NOTICE OF DECISION
Site Design Review for Lyrics Cafe – Commercial Remodel
File No. DR223-0003 – 808/814 E Hancock Street

Site Design Review for Lyrics Cafe – Commercial Remodel File No. DR223-0003 – 808/814 E Hancock Street

FILE NO: DR223-0003

REQUEST: Remodel café/coffee shop

Figure 1. Vision Clearance Triangles for Drive-Through Area of Subject Property

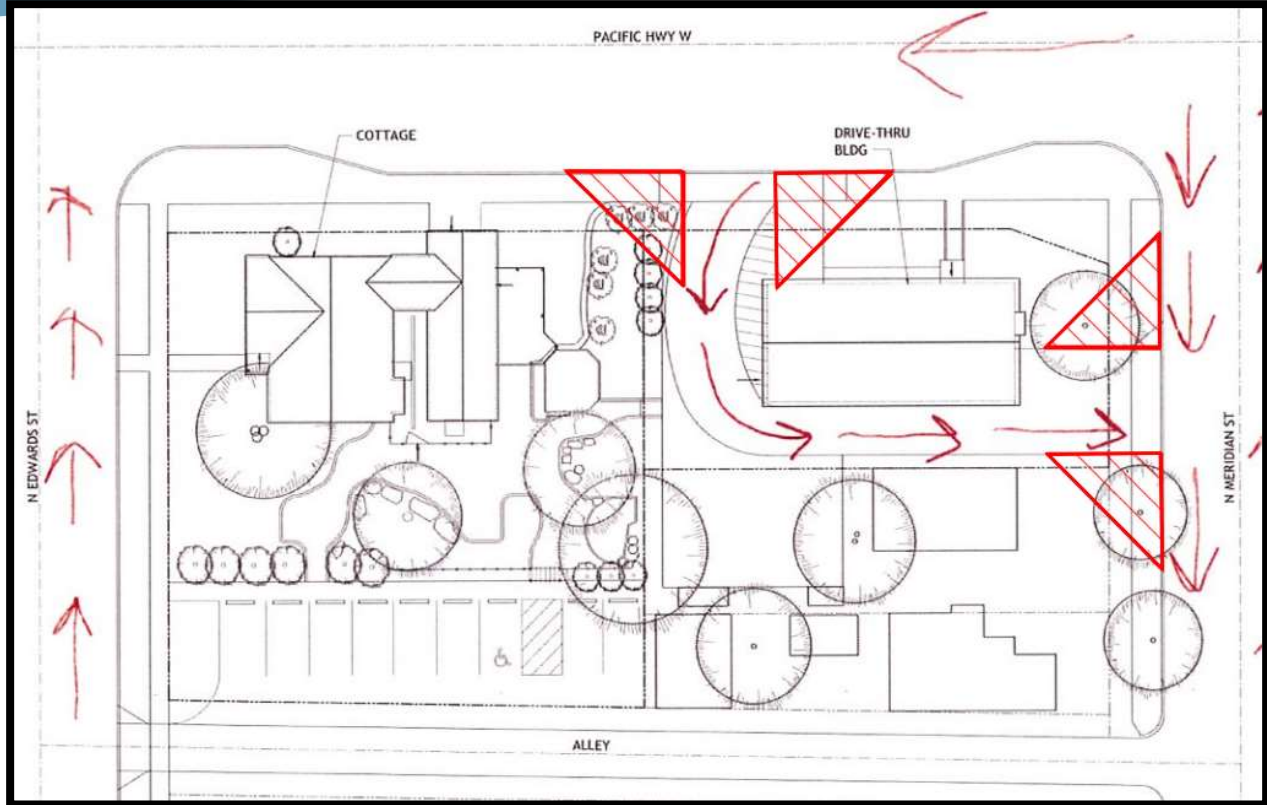
- Vision Clearance Triangle for drive-through entrance from E Hancock Street: No structures are located within or will be added to the vision clearance triangle area. As depicted in the figure below, landscaping of an undefined height is located within the vision clearance triangle. Because the landscaping within the vision clearance triangle, the applicant shall be required to ensure that that vision clearance triangle of the drive-through entrance is kept free of all visual obstructions from two and one-half feet to nine feet above the curb line.

- Vision Clearance Triangle for Drive-Through Exit onto drive-through exit onto N Meridian Street: No structures are located within or will be added to the vision clearance triangle area. As depicted in the figure below, landscaping of an undefined height is located within the vision clearance triangle. Because the landscaping within the vision clearance triangle, the applicant shall be required to ensure that that vision clearance triangle of the drive-through exit is kept free of all visual obstructions from two and one-half feet to nine feet above the curb line.

The criterion will be met if the aforementioned conditions of approval are adhered to.

Landscape Plan

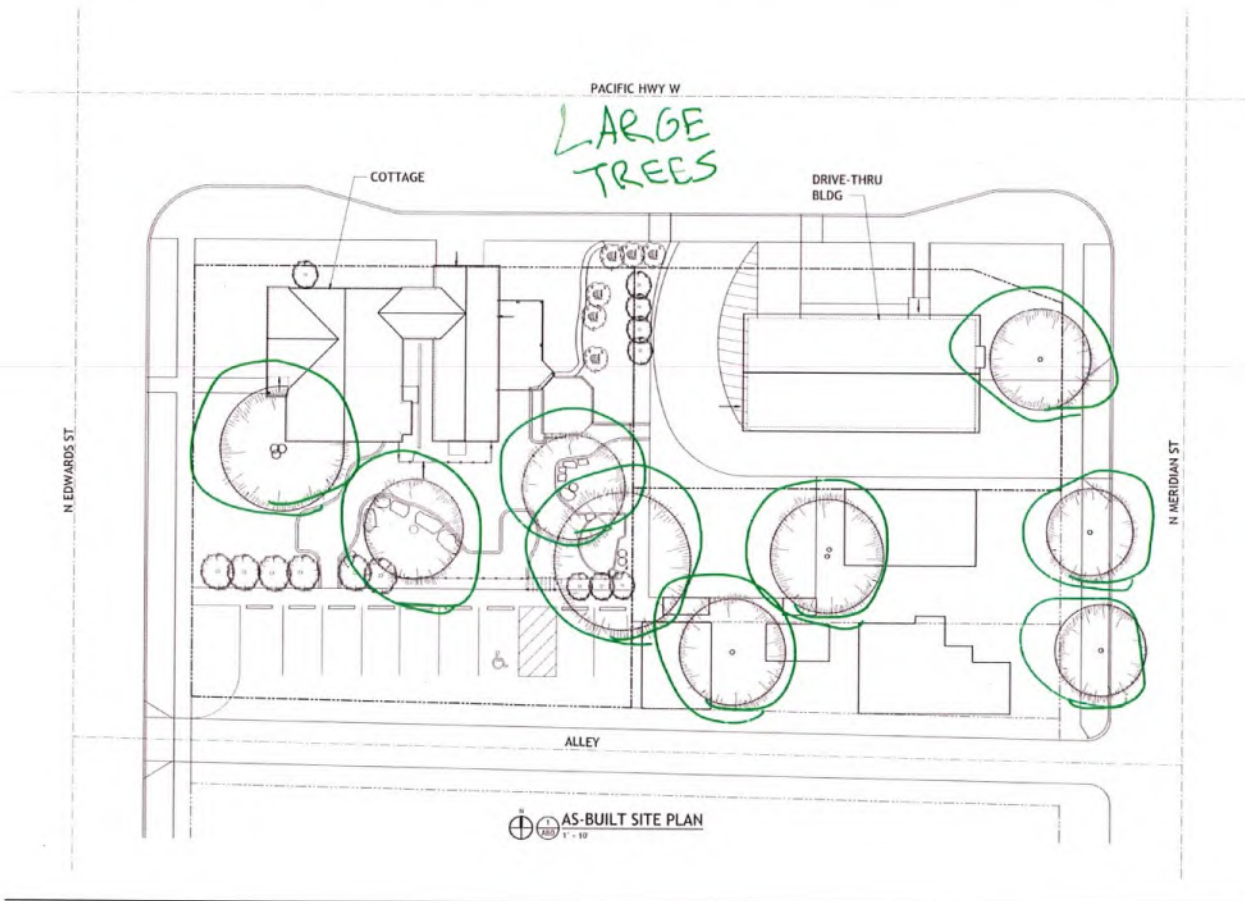
The E Hancock frontage is a curb-tight sidewalk with only one tree and a landscaping buffer depicted in the landscaping plan. Because the E Hancock Street frontage is a major arterial and no trees are depicted in front of 808 and 814 E Hancock for more than 111 feet, the Applicant shall ensure that three street trees of at least a 2-inch caliper tree trunk are planted or otherwise maintained along the E Hancock Street frontage.

6. **Street Trees:** The Applicant shall ensure that three street trees of at least a 2-inch caliper tree trunk are planted or otherwise maintained along the E Hancock Street frontage of the subject property.

Existing
Cafe
Remodeled

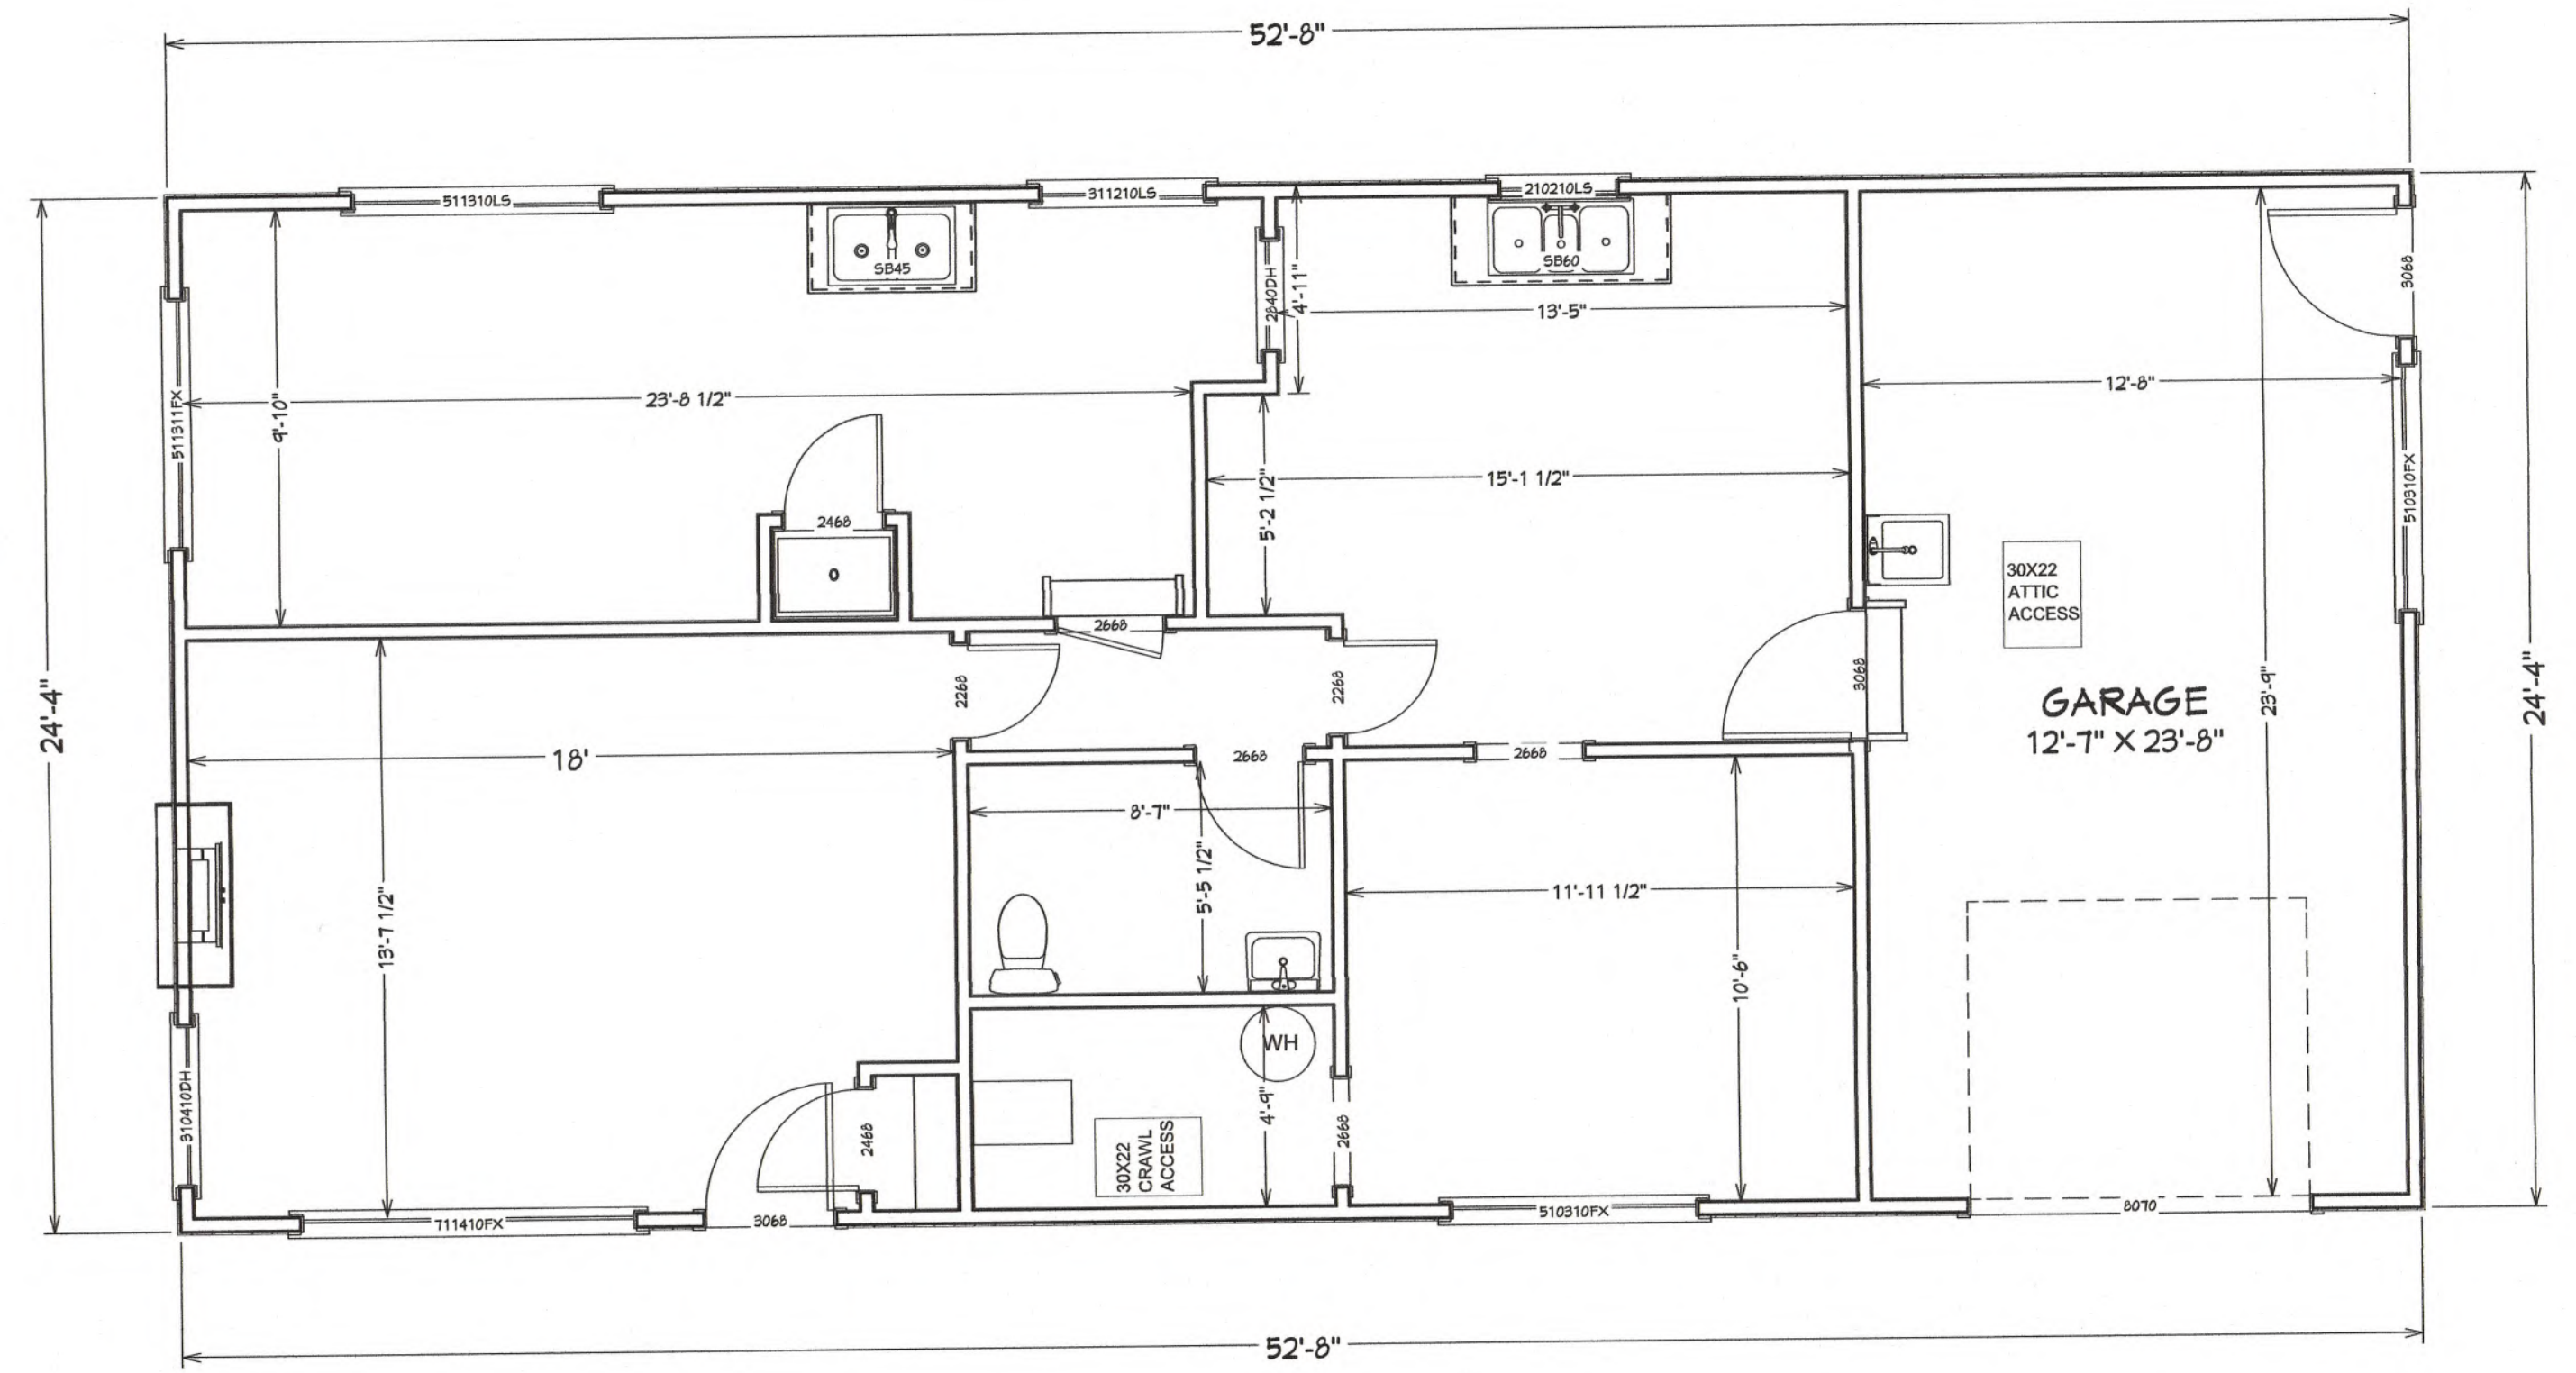
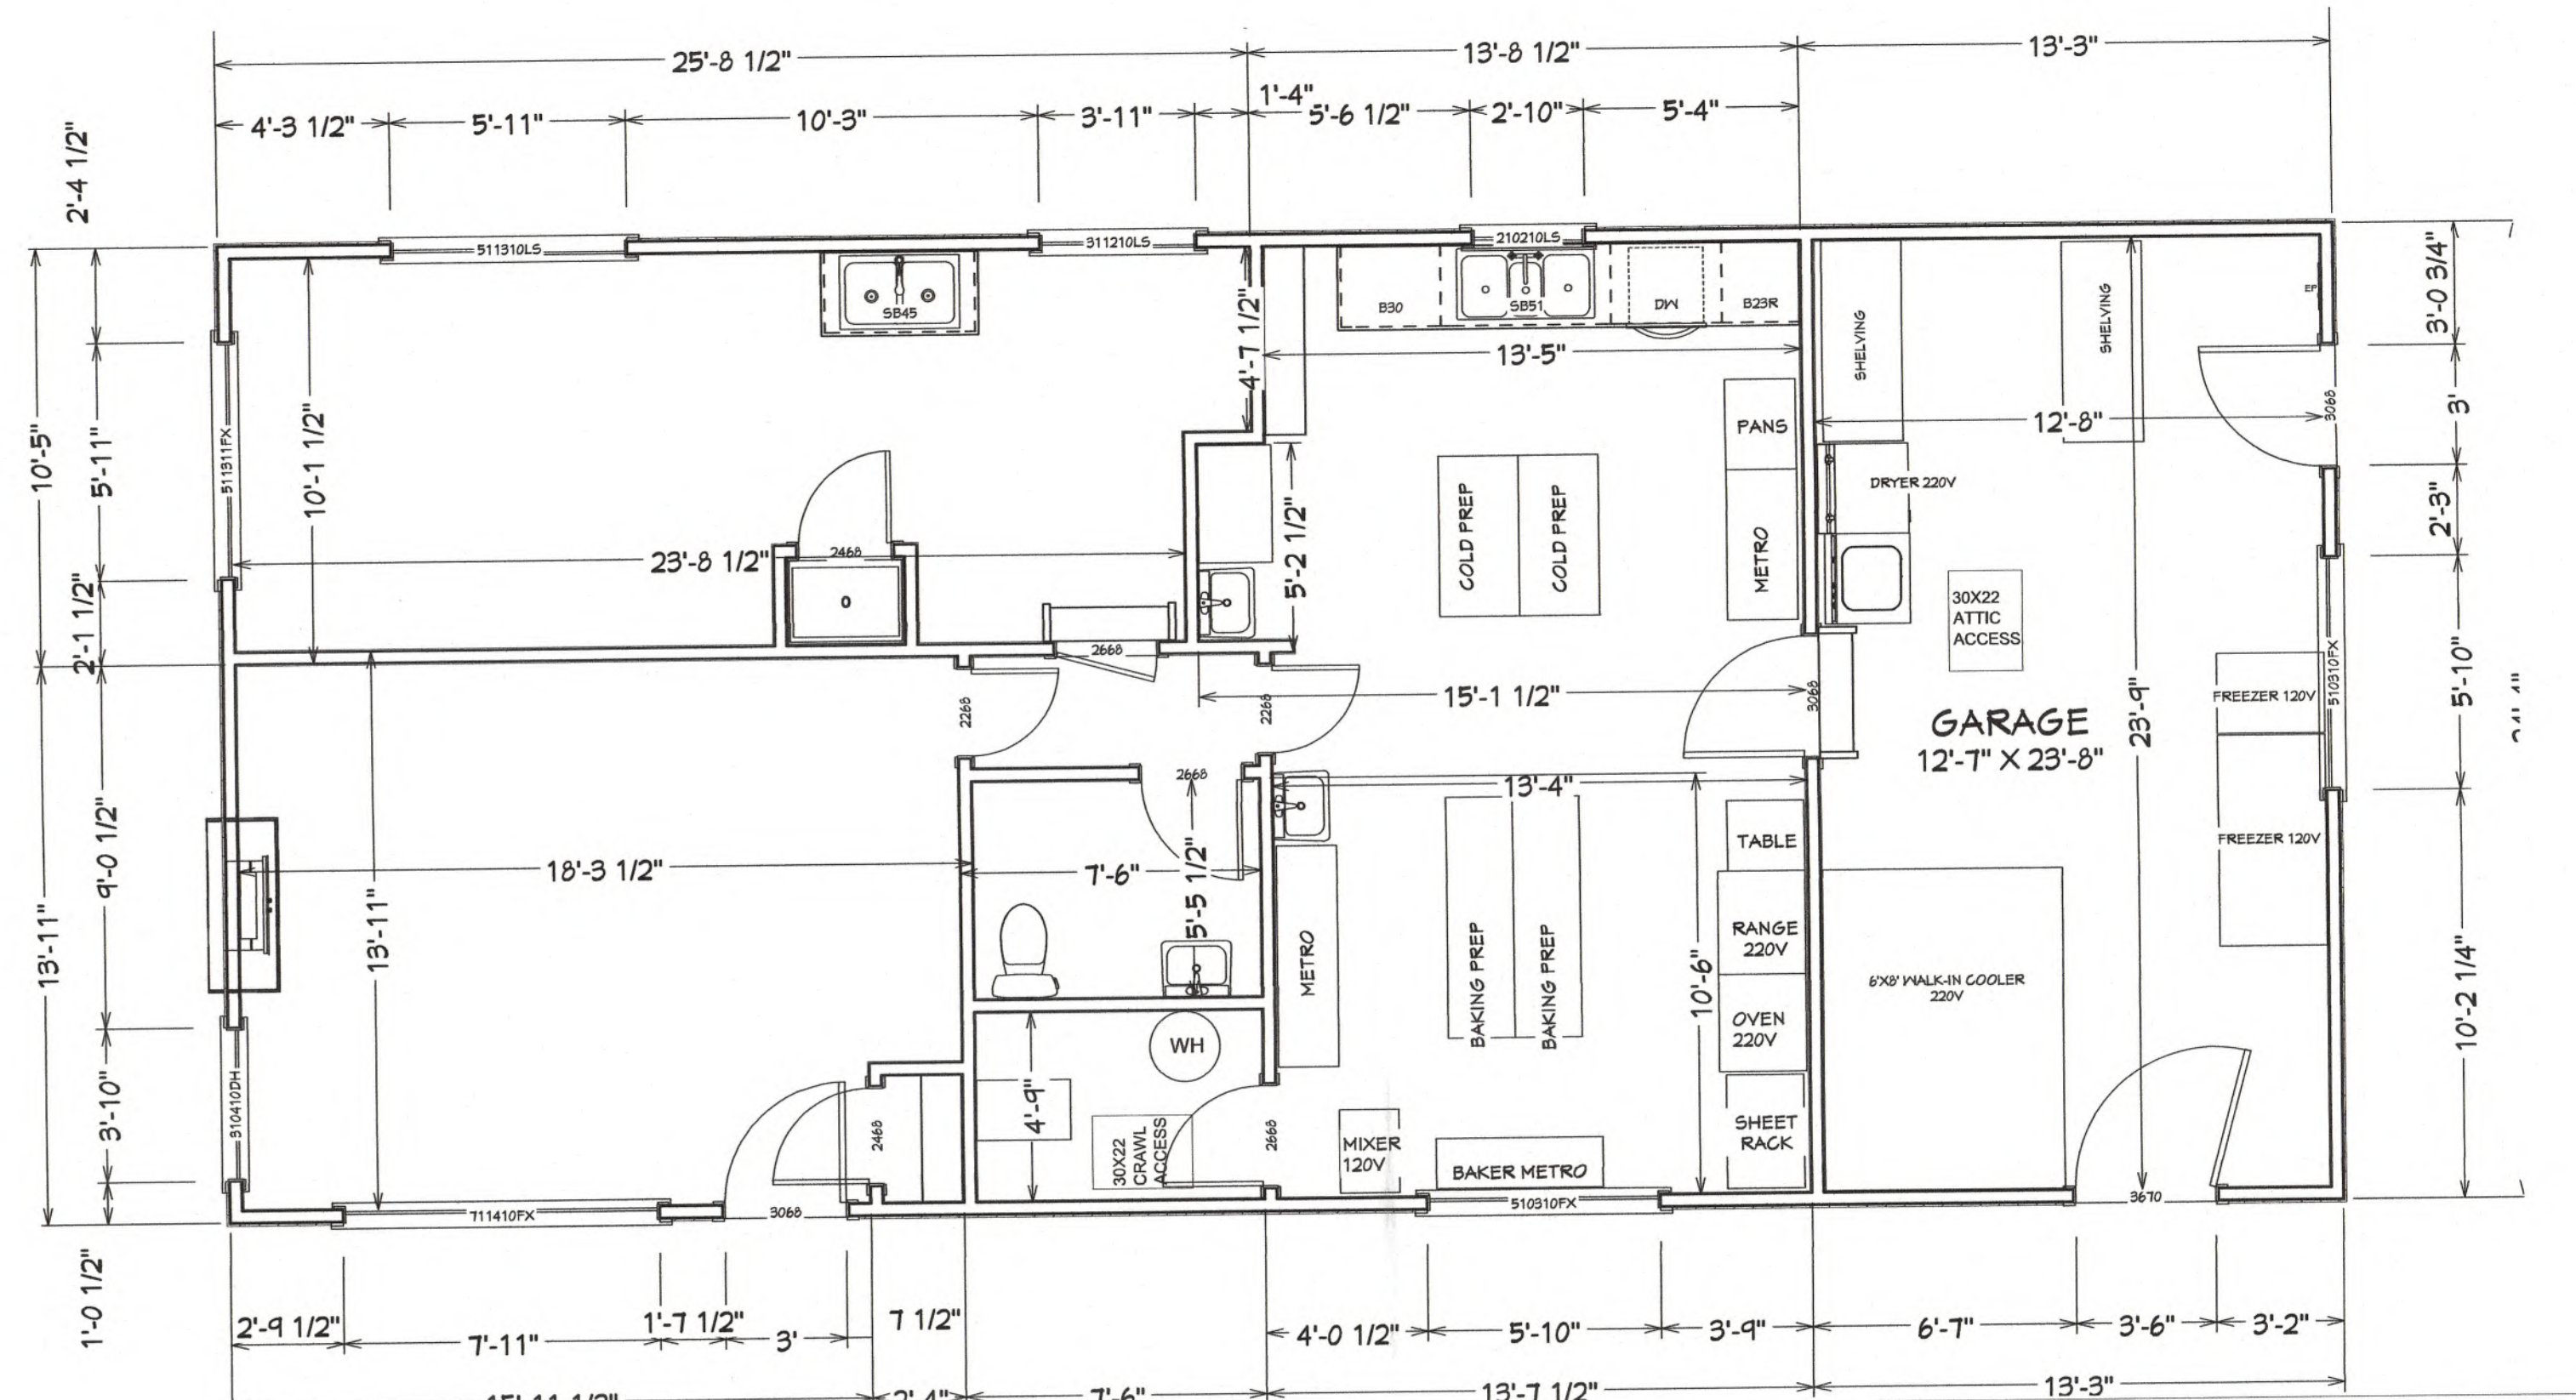
The application materials (narrative and Sheet 3) indicate that removal of the chimney/fireplace in Building 1 will occur. However, conflicting application materials (building elevations, Sheet A2) indicate that the chimney for Building 1 will remain in place. Because the discrepancy exists within submitted application materials (Sheet 3 and Sheet A2) of the application materials, prior to issuance of building permits for the building at 808 E Hancock Street, the Applicant shall either submit revised building elevations that depict the roof configuration with the chimney removed or submit revised building plans that depict retention of the chimney/fireplace.

3. **Revision of Plans for Building Permits:** Prior to issuance of building permits for the building at 808 E Hancock Street, the Applicant shall either submit revised building elevations that depict the roof configuration with the chimney removed or submit revised building plans that depict retention of the chimney/fireplace.
